**FORM VT-3C**  
 CONTAINMENT INSERVICE INSPECTION  
 RECORD OF VT-3C EXAMINATION

STATION/UNIT: Indian Point 2 COMPONENT NO.: VCC-35  
 ZONE NUMBER: IWL-148-006 DRAWING NO.: 320869  
 EQUIPMENT USED: Celestron Giant 20x80 Binoculars (Ser. No. 990176)

**CONCRETE INSPECTION ZONE IWL-148-006**  
 (EXTERIOR DEVELOPED VIEW, LOOKING FROM OUTSIDE)

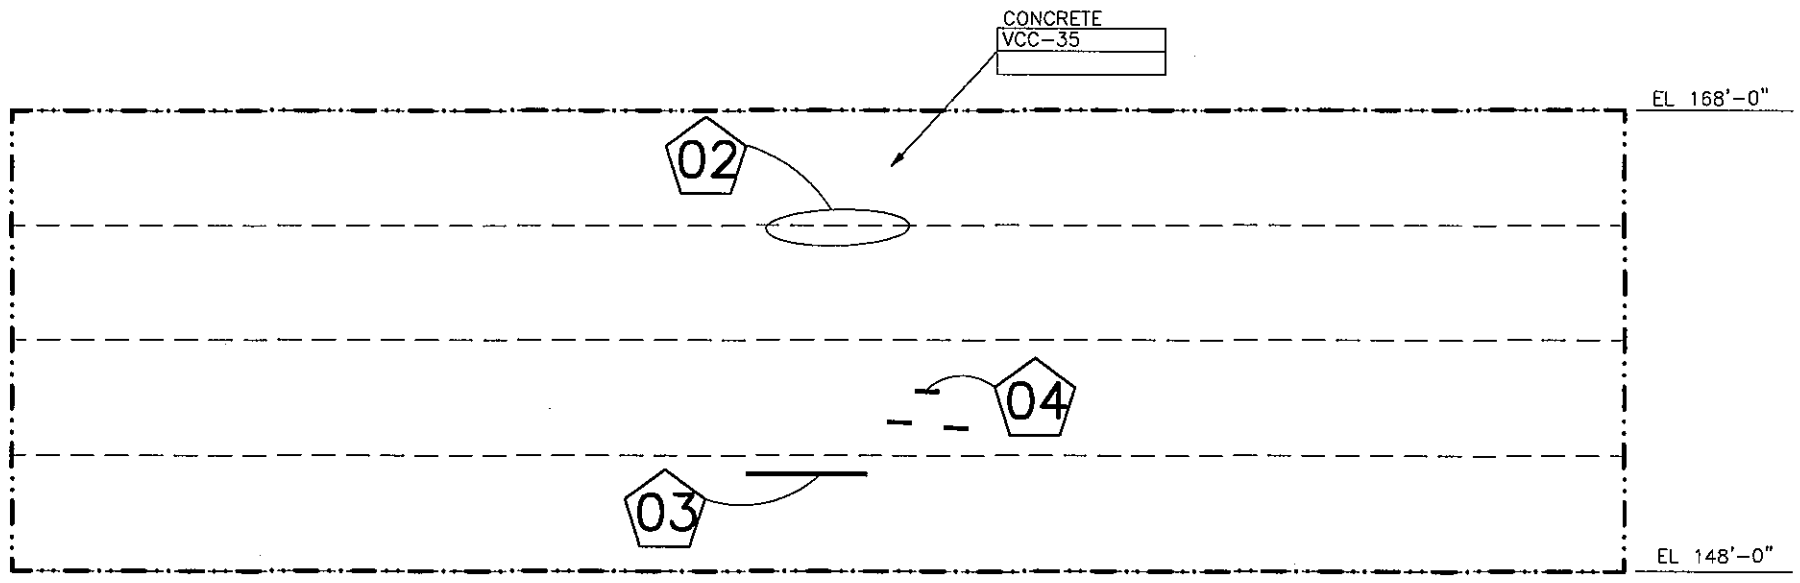
No.	Comment	Initials
1	Non-uniformity of surface color and texture observed at various locations in the zone. The condition does not indicate significant material deterioration of the concrete.	RW
2	White desposit from concrete cover patch over exposed rebar at construction joint 6" long. See photos 00052606 and 00052607	RW
3	Cadweld exposure from 9" long concrete spalling. See photo 00052609	RW
4	Rebar exposure at 3 spots, 1" to 3" long due to 1/2" cover concrete spall. See photo 00052608	RW

Comments: The surface texture (comment #1) resulted from original construction and does not reflect degradation of the containment. The leaching (comment #2) is not significant. Engineer evaluation is needed for the reinforcing steel (comments #3 & #4).

**CONCRETE INSPECTION ZONE IWL-168-001**  
(EXTERIOR DEVELOPED VIEW, LOOKING FROM OUTSIDE)

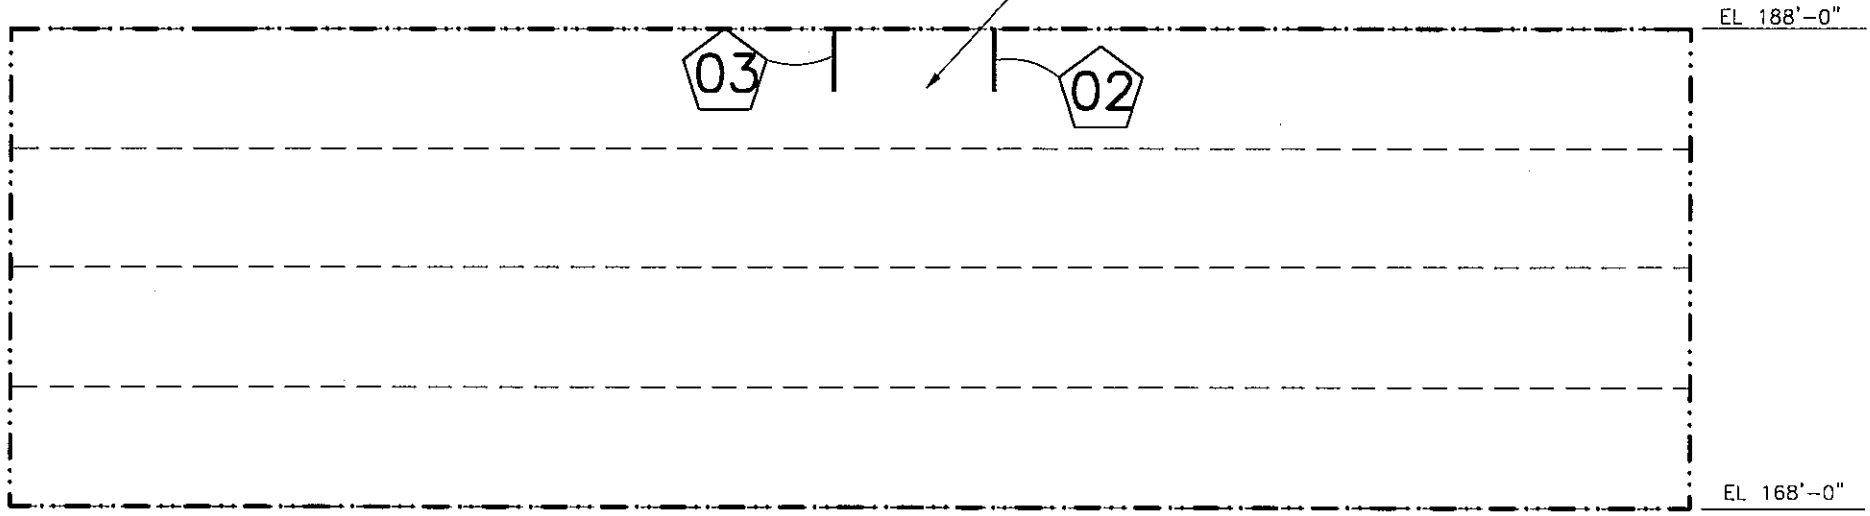
No.	Comment	Initials
1	Non-uniformity of surface color and texture observed at various locations in the zone. The condition does not indicate significant material deterioration of the concrete.	RW
2	minor leaching from dome spring line construction joint	RW
3	2' long leaching from dome spring line construction joint	RW

Comments: The surface texture (comment #1) resulted from original construction and does not reflect degradation of the containment. The leaching (comment #2) is not structurally significant.

**CONCRETE INSPECTION ZONE IWL-168-002**  
(EXTERIOR DEVELOPED VIEW, LOOKING FROM OUTSIDE)

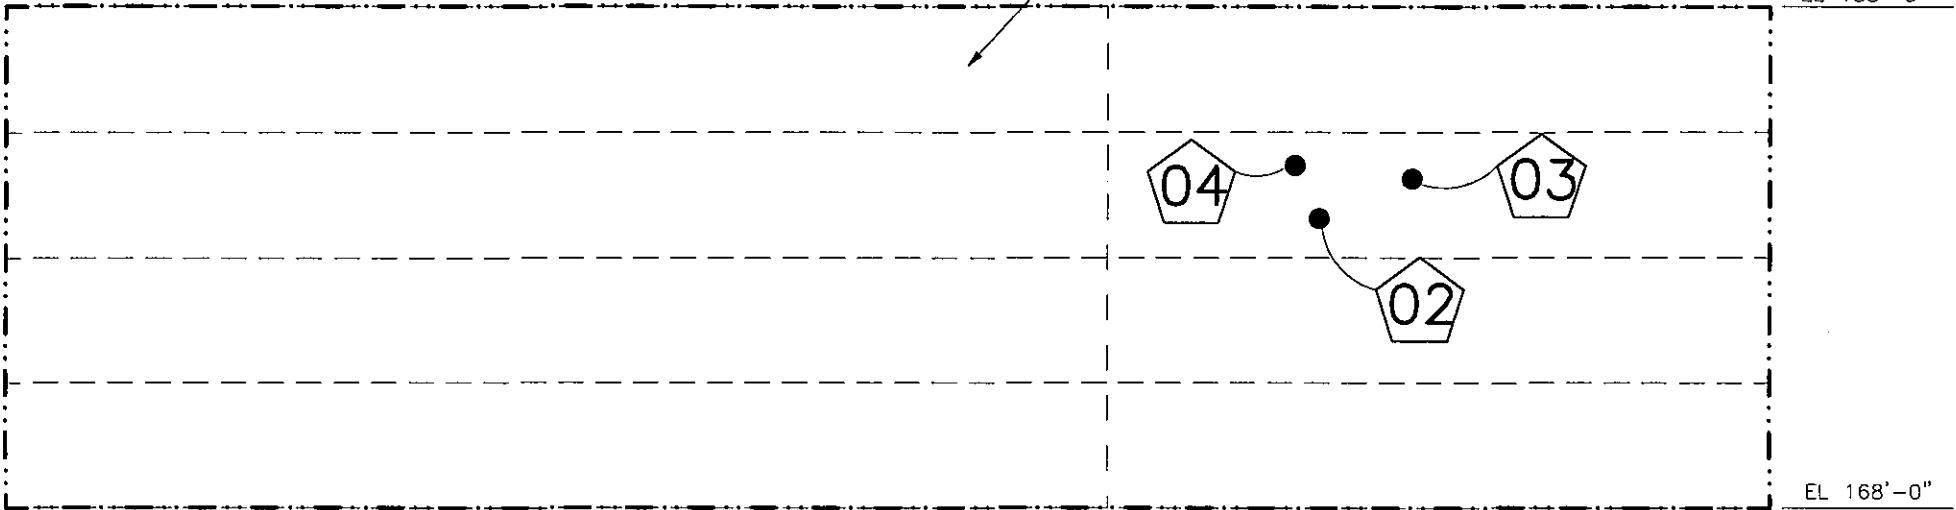
No.	Comment	Initials
1	Non-uniformity of surface color and texture observed at various locations in the zone. The condition does not indicate significant material deterioration of the concrete.	CAS
2	A small spot of steel is exposed and corroded. It is not known whether this is reinforcing steel. See photo 00053142	CAS
3	A small spot of steel is exposed and corroded. It is not known whether this is reinforcing steel. See photo 00053143	CAS
4	The concrete has cracked & bulged in a small area that is likely to spall off. By comparison to other similar areas it is believed to be a cadweld or reinforcing steel which is corroded due to insufficient concrete cover. See photo 00053144	CAS

Comments: The surface texture (comment #1) resulted from original construction and does not reflect degradation of the containment. Engineering evaluation is needed for the rebar issues (comments #2, #3 & #4).

**CONCRETE INSPECTION ZONE IWL-168-003**  
 (EXTERIOR DEVELOPED VIEW, LOOKING FROM OUTSIDE)

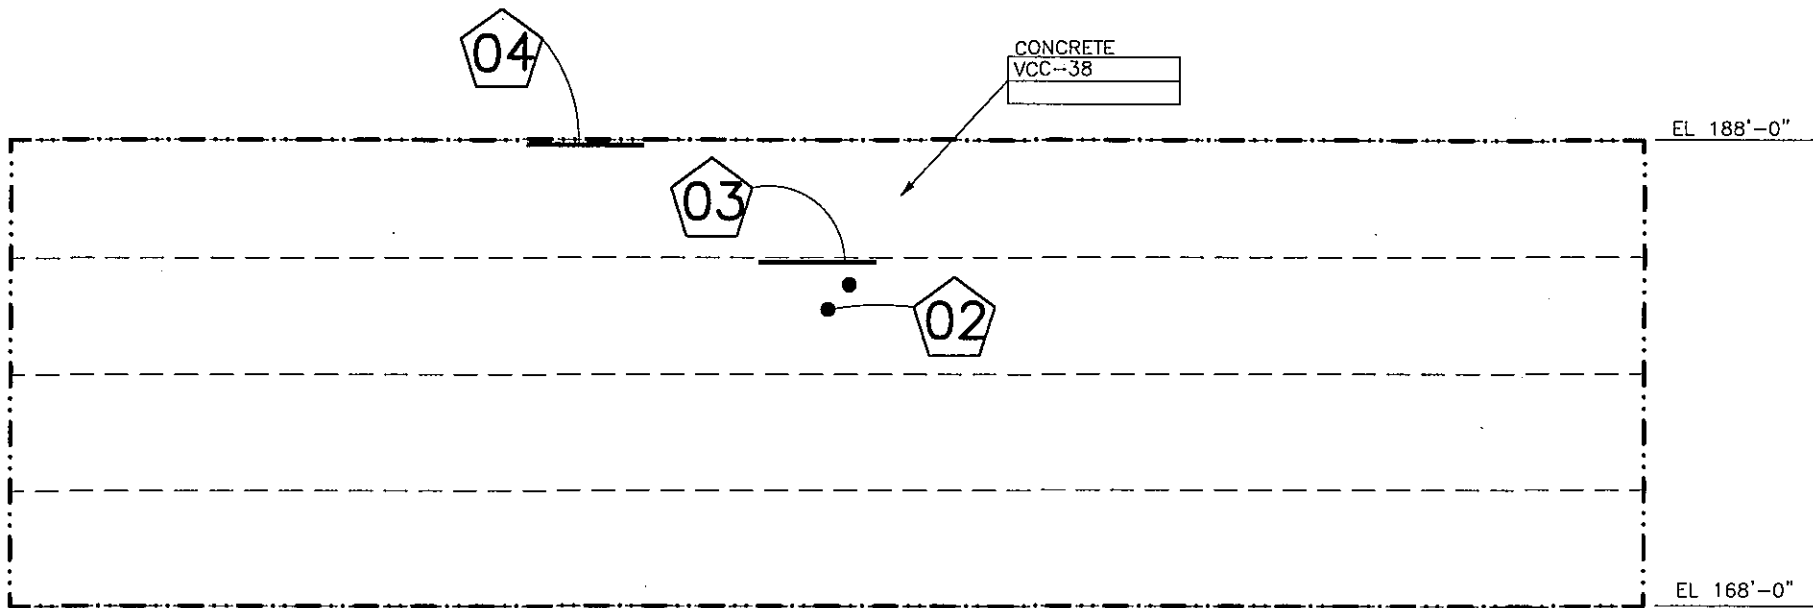
No.	Comment	Initials
1	Non-uniformity of surface color and texture observed at various locations in the zone. The condition does not indicate significant material deterioration of the concrete.	RW
2	2 voids exposing 1" corroded steel. See photo 00053103	RW
3	9"x3" concrete spall exposing cadweld sleeve and insufficient concrete cover. See photo 00053102	RW
4	9"x3" concrete spall exposing cadweld sleeve and insufficient concrete cover. See photo 00053101	RW

Comments: The surface texture (comment #1) resulted from original construction and does not reflect degradation of the Containment. Engineering evaluation is needed for the exposed/corroded reinforcing steel rodwelds.

**CONCRETE INSPECTION ZONE IWL-168-006**  
 (EXTERIOR DEVELOPED VIEW, LOOKING FROM OUTSIDE)

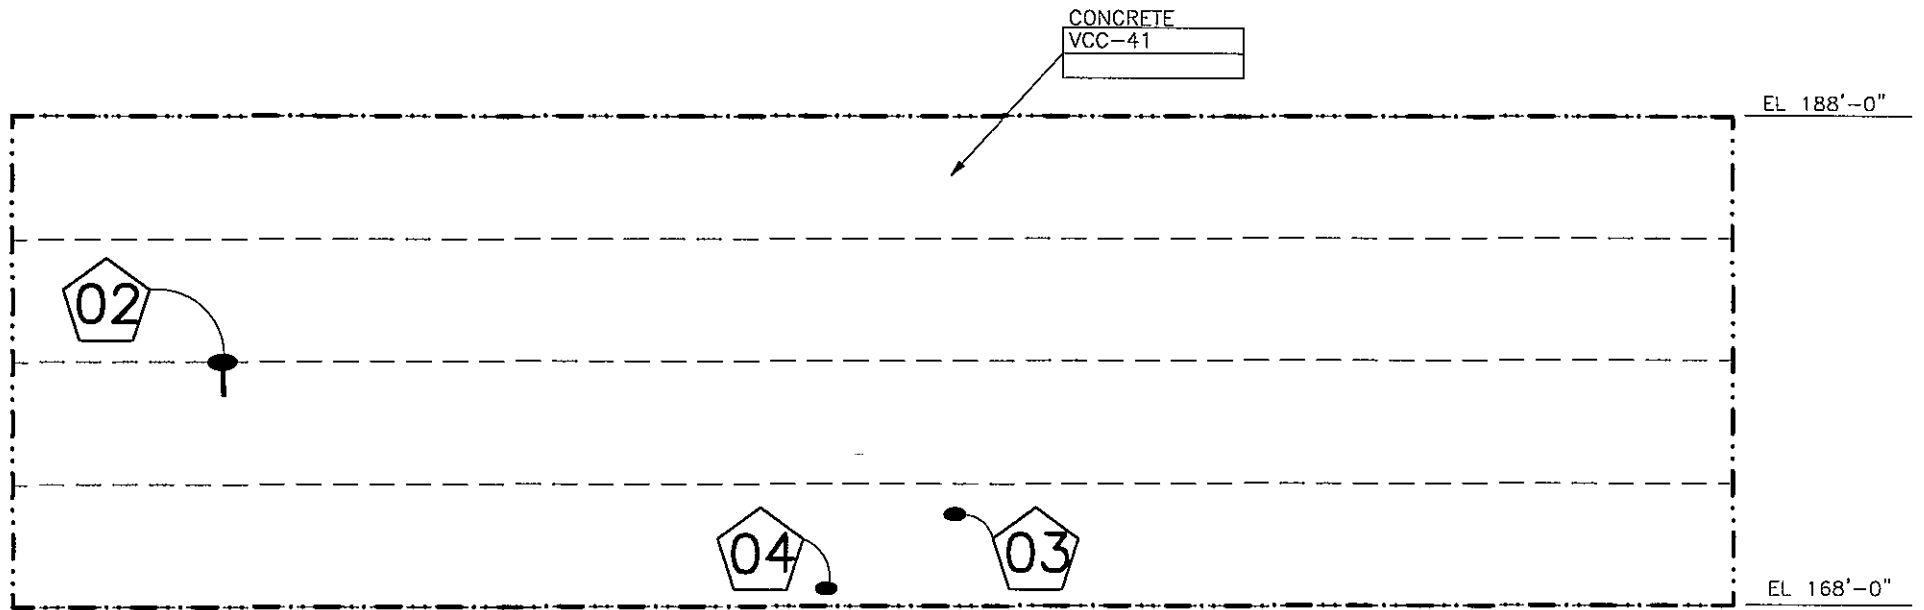
No.	Comment	Initials
1	Non-uniformity of surface color and texture observed at various locations in the zone. The condition does not indicate significant material deterioration of the concrete.	RN
2	12" long Efflorescence (white deposit) from 3" radius chipped concrete (spall). See photo 00060101	RN
3	10" long cadweld sleeve exposed due to spalling of (1/2") cover concrete. See photos 00052604 and 00052605	RN
4	10" long cadweld sleeve exposed due to spalling of (1/2") cover concrete. See photos 00052604 and 00052605	RN

Comments: The surface texture (comment #1) resulted from original construction and does not reflect degradation of the containment. The leaching (comment #2) is not structurally significant. Engineering evaluation is needed for the exposed reinforcing steel (comments #3/#4).

00053129.jpg

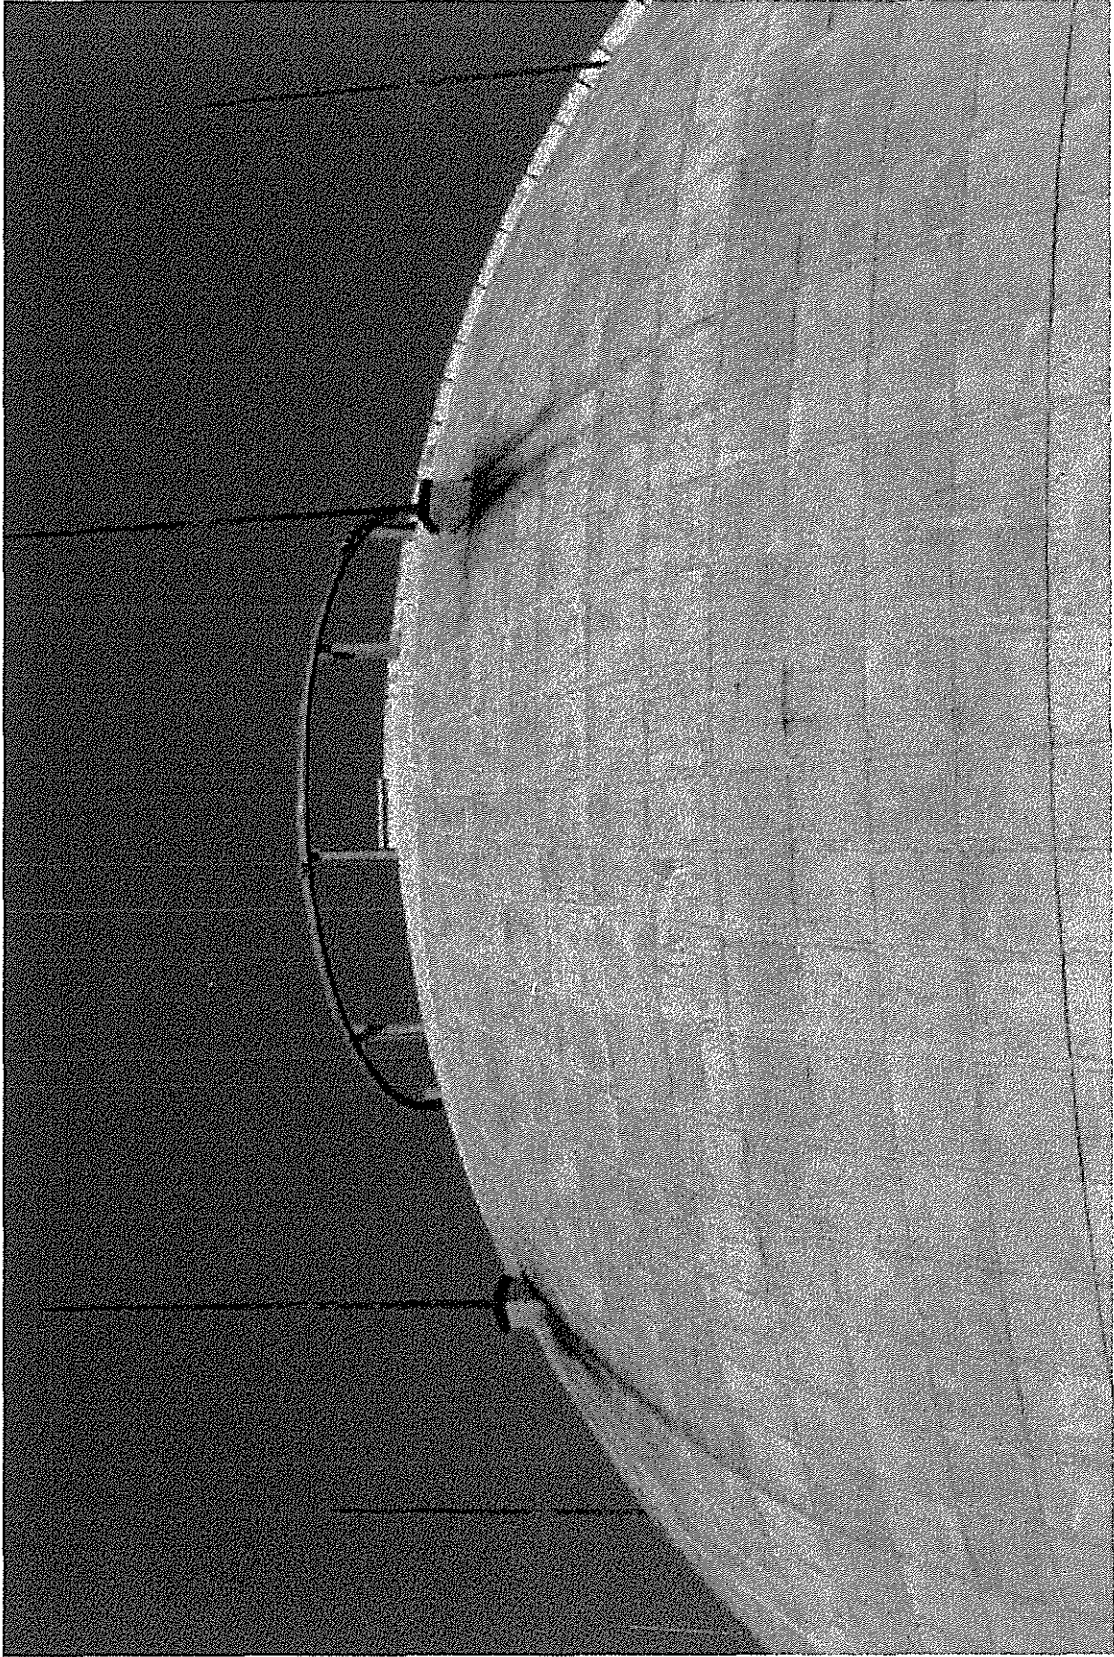
No.	Comment	Initials
1	Large rust stains are evident on the surface of the dome at and below the concrete pier which supports the lightning rod. The rust is obviously dripping down from the lightning rod base support plate. No cracking is evident in the area so rebar corrosion is not suspected. See photo 00053129	RW

**CONCRETE INSPECTION ZONE IML-DOME-005**  
 (EXTERIOR DEVELOPED VIEW, LOOKING FROM OUTSIDE)

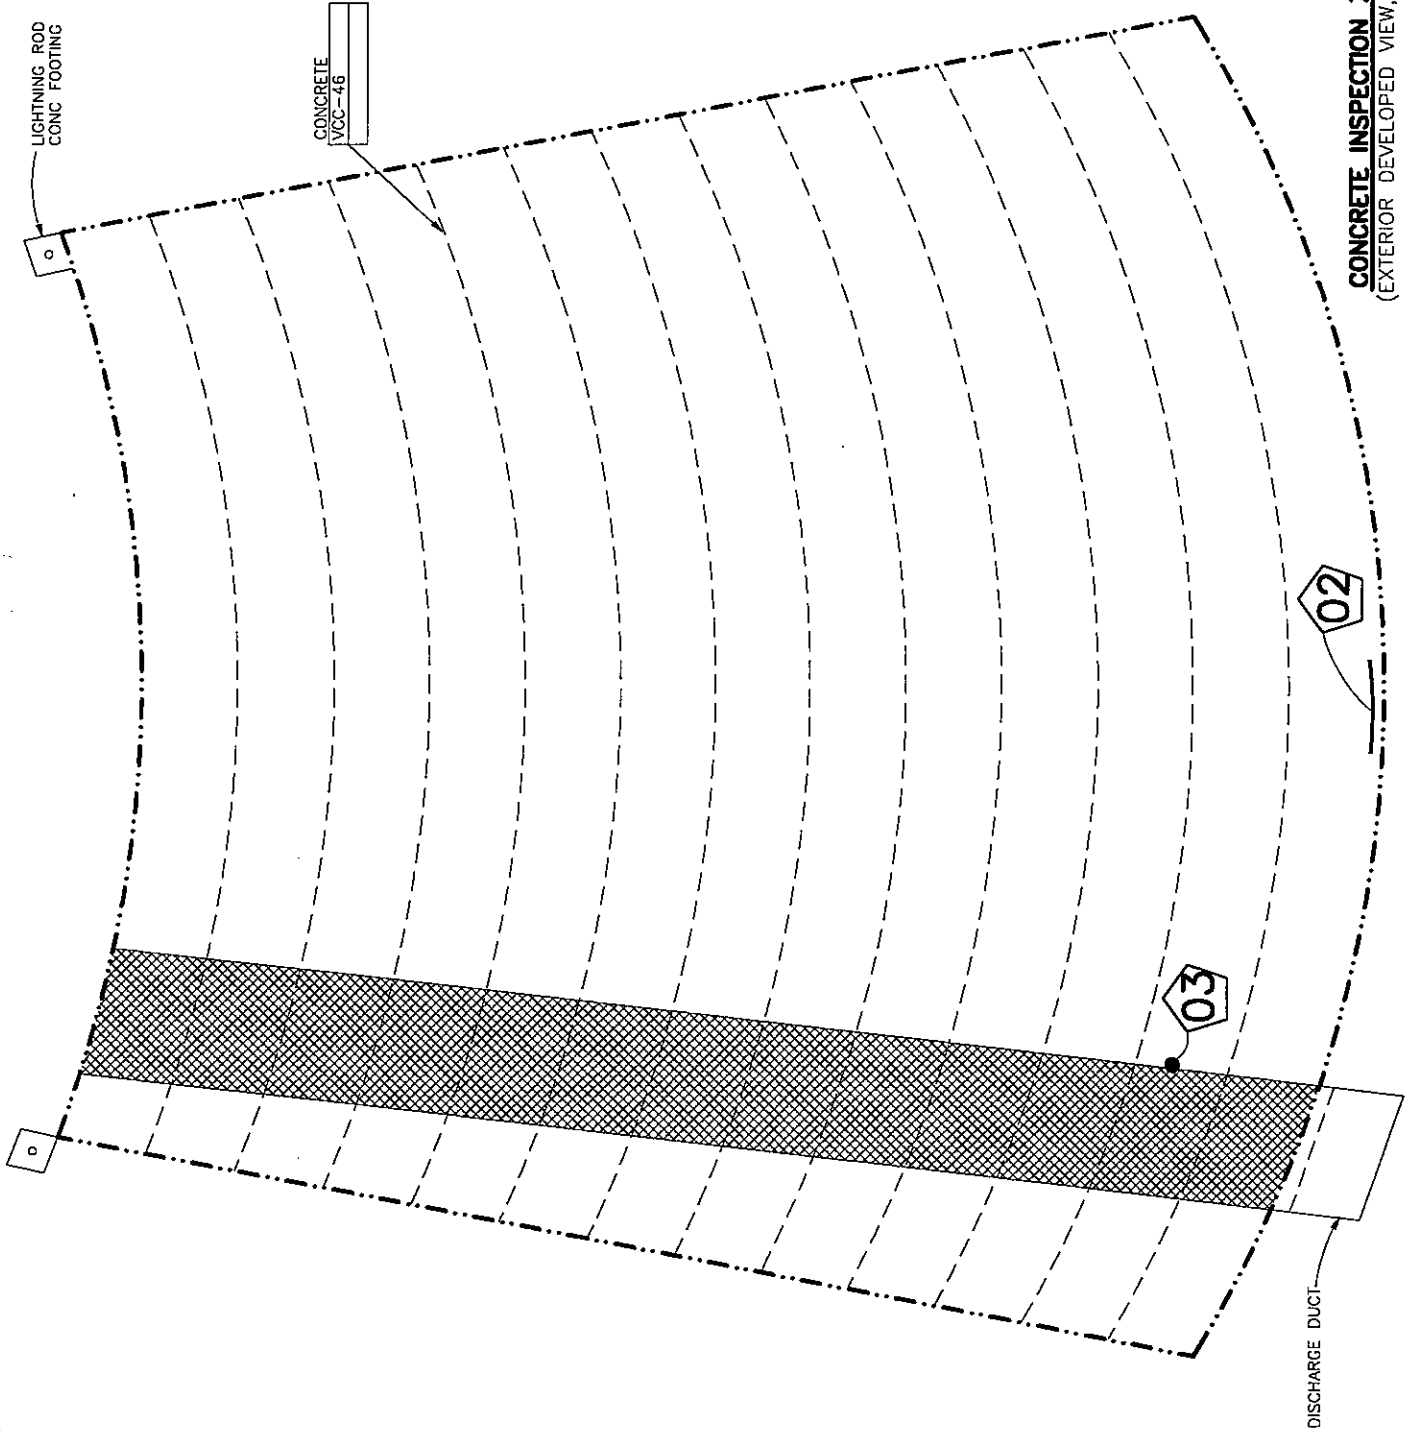
No.	Comment	Initials
1	Large rust stains are evident on the surface of the dome at and below the concrete pier which supports the lightning rod. The rust is obviously dripping down from the lightning rod base support plate. No cracking is evident in the area so rebar corrosion is not suspected. Corrosion staining is also evident at surface attachments for the discharge duct due to rusting of the attachment plates. See photo 00060104	RW
2	4' long horizontal crack and about 20 to 30 mils in width, 15" above the dome spring line. See photo 00060103	RN
3	3" diameter void (shallow hole) under the duct edge. See photo 00060106	RN

Comments : Engineering evaluation is needed to address the void (comment #3).
